MISSISSIPPI POWER & LIGHT COMPANY

SUBJECT: Grand Gulf Nuclear Station
Units 1 and 2
Docket Nos. 50-416 and 50-417
File 0260/0862
Transmittal of Proposed FSAR
Changes and Responses to NRC
Questions
AECM-81/277

MISSISSIPPI POWER & LIGHT COMPANY
GRAND GULF NUCLEAR STATION
UNITS 1 & 2
FINAL SAFETY ANALYSIS REPORT

SETTLEMENT VS TIME
UNIT 1
TURBINE BUILDING
FIGURE 2.5-75b Sheet 1

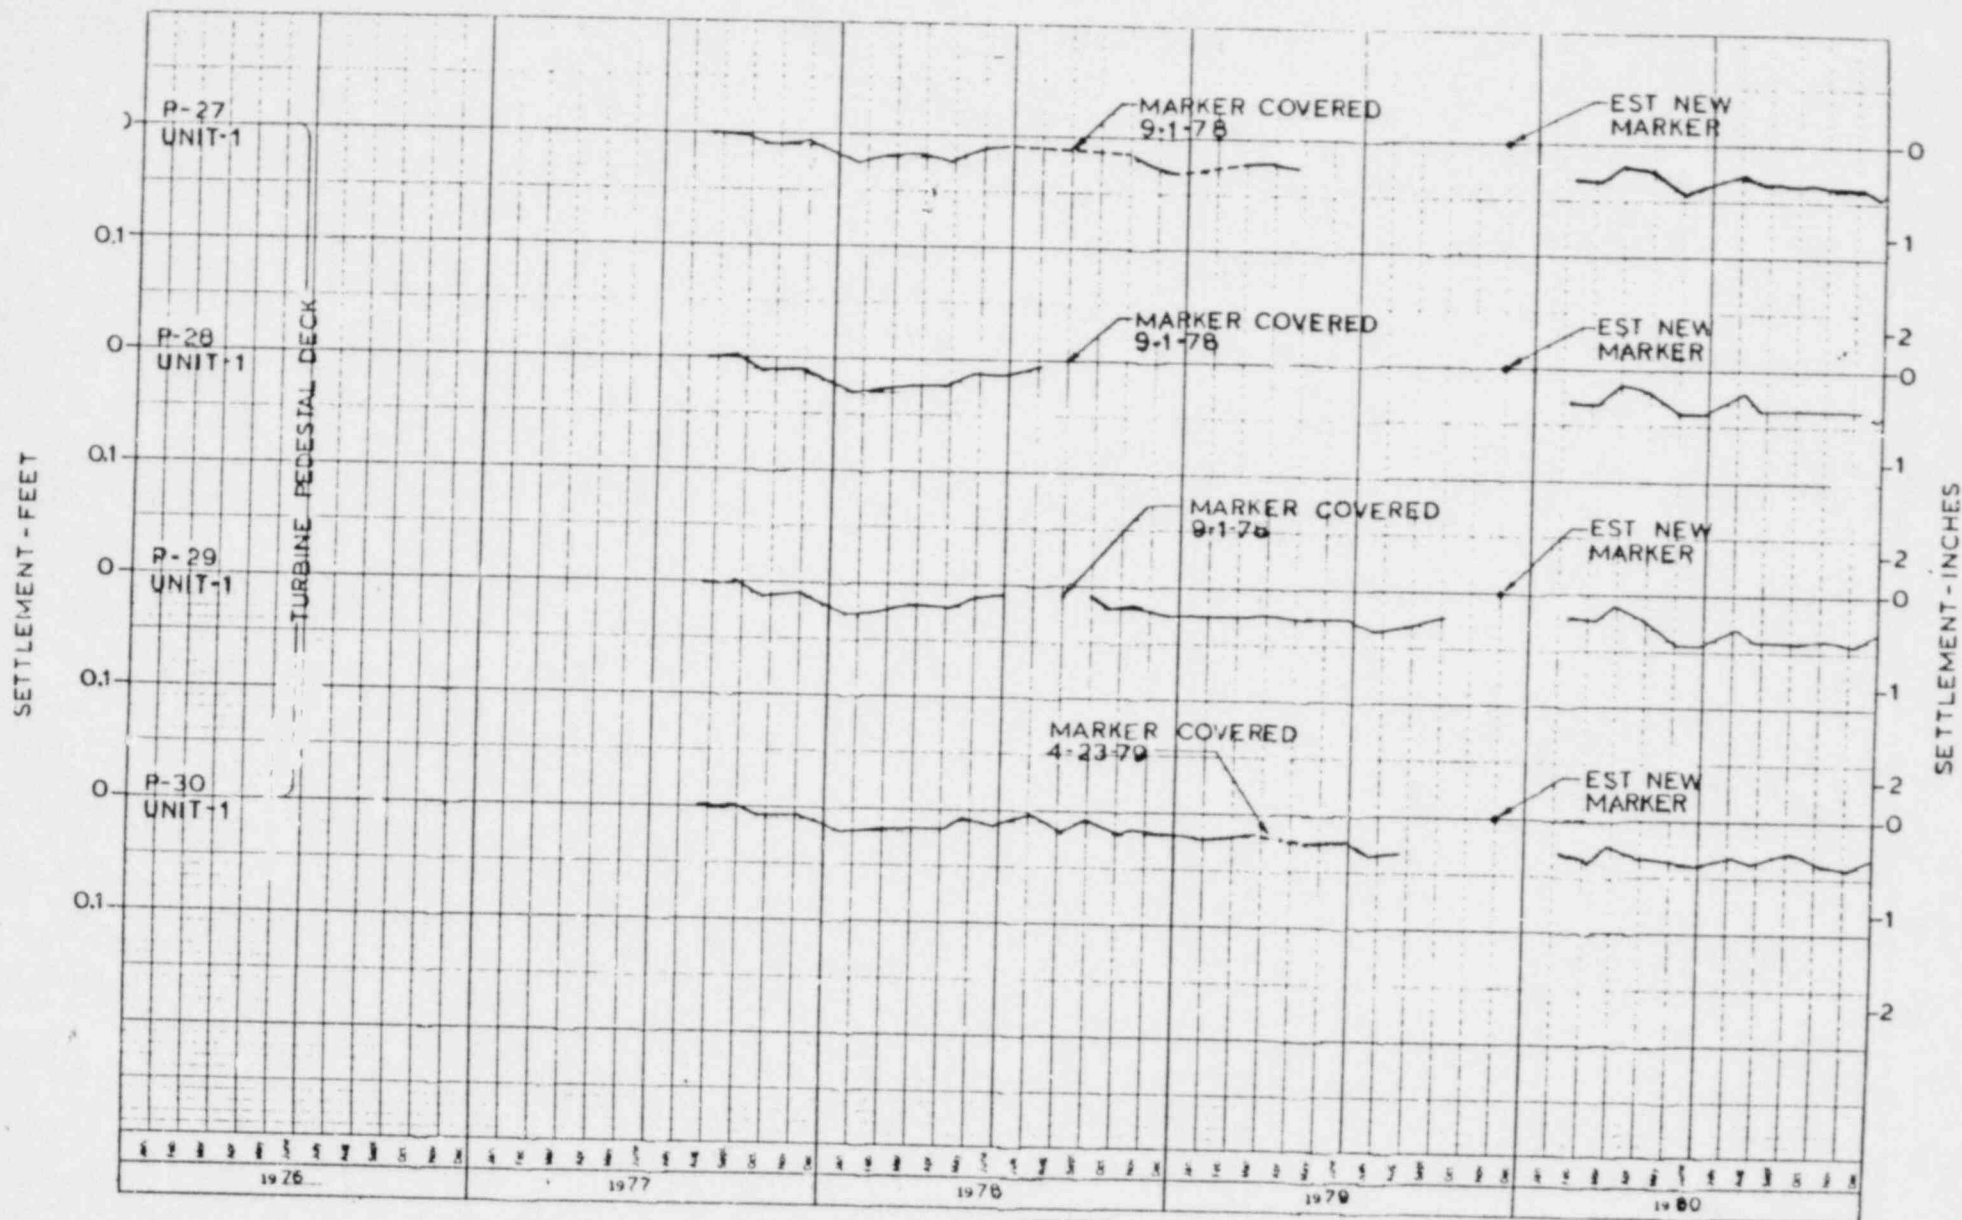
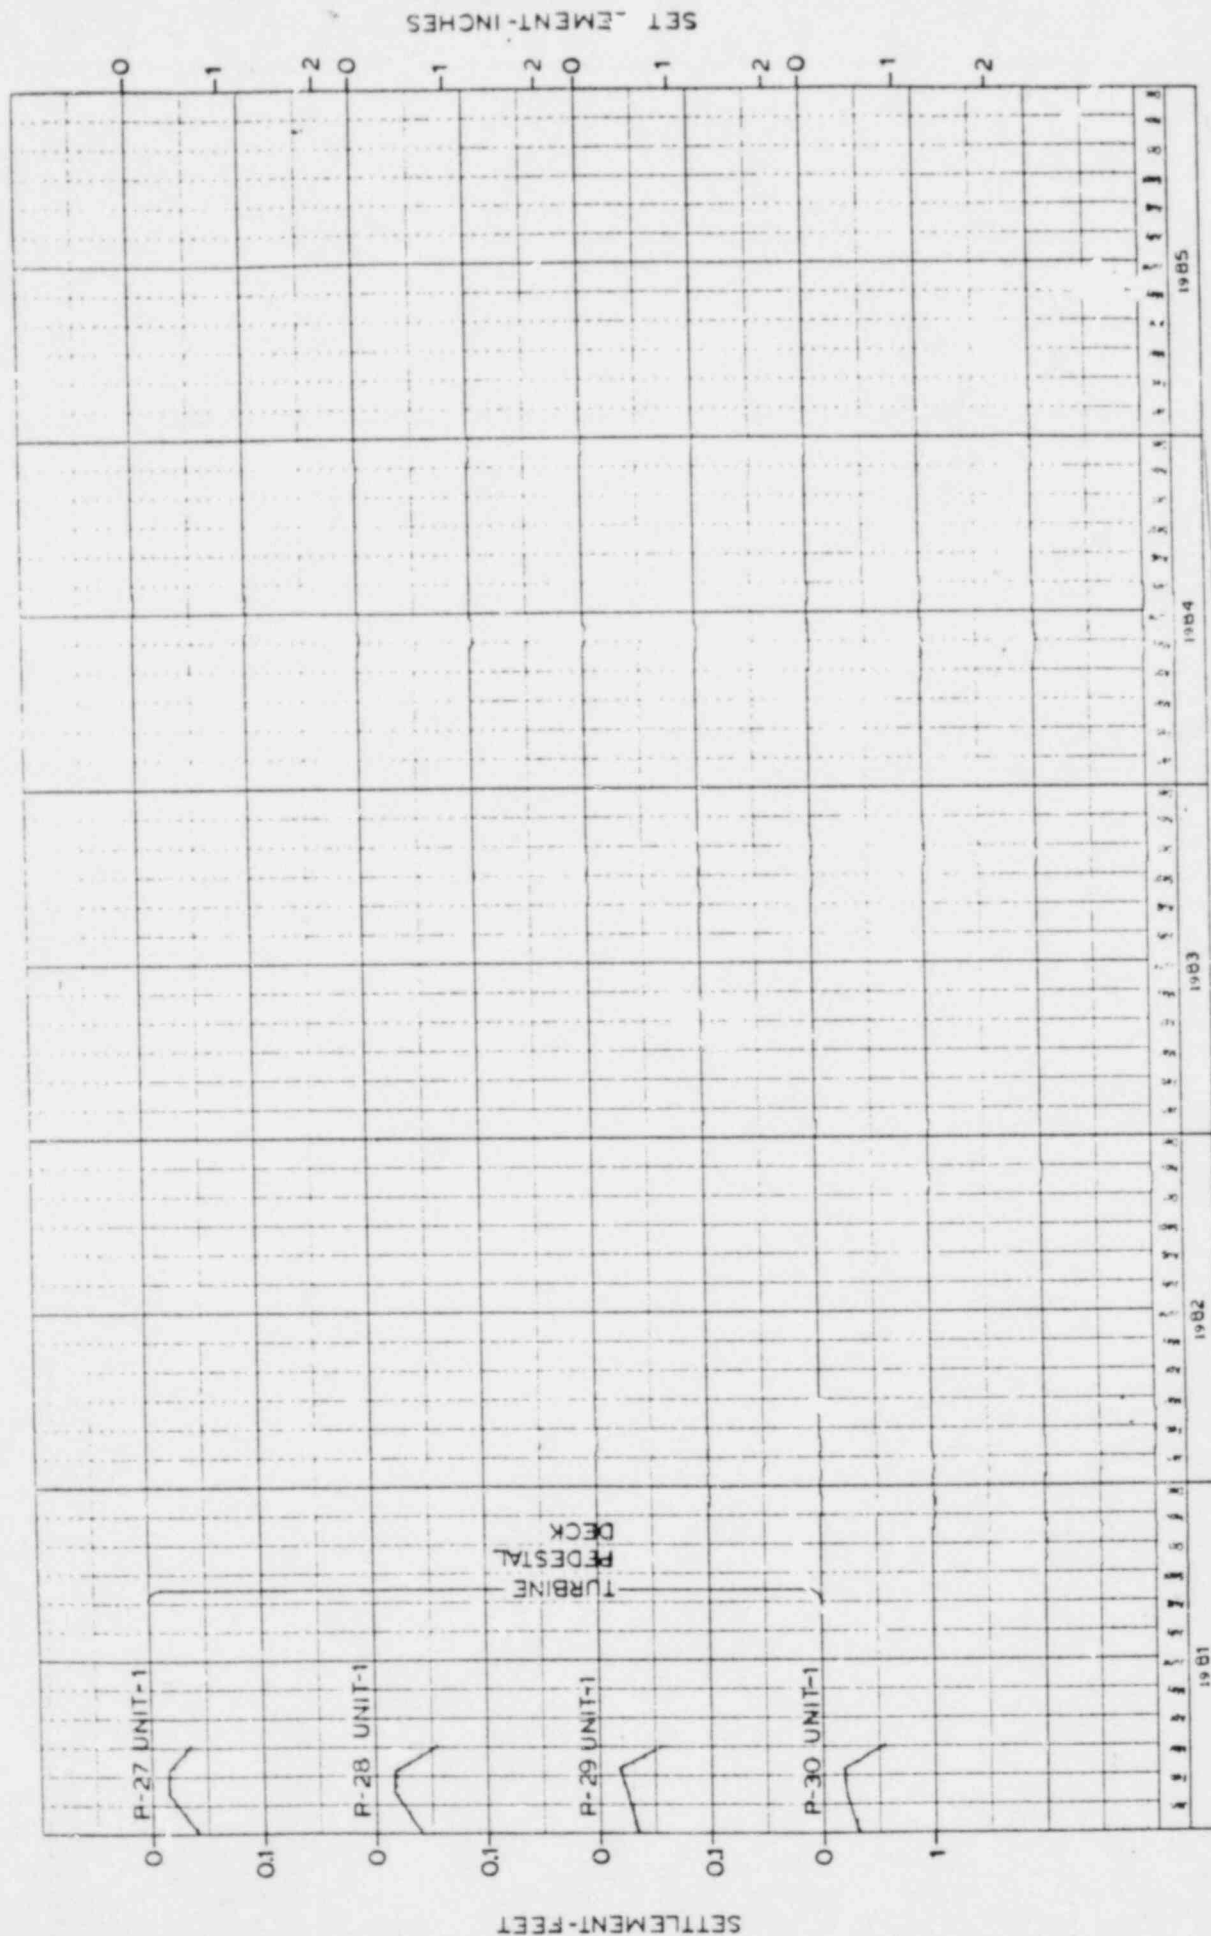
362.7
(2.5.4.13.1) Your response to NRC Question 362.5 (page Q&R 2.5-14, Amendment 30) is not complete. Indicate what measured value of differential settlement would cause code allowable stresses to be exceeded for individual buildings and buried piping and require notification of NRC. Provide a table of these values and the limiting stress criteria. Update the plots which show settlement recorded to date versus time; this is particularly important since construction of Unit 2 was still underway when your response to Question 362.5 was being developed.

The response to this question is given in revised subsection 2.5.4.13.1, revised Table 2.5-10 and revised Figures 2.5-75a through 2.5-75h.

Turbine building	3"
Radwaste building	3"
Control building	3"
Containment building	3.5"
Auxiliary building	3.5"
Diesel generator building	3"
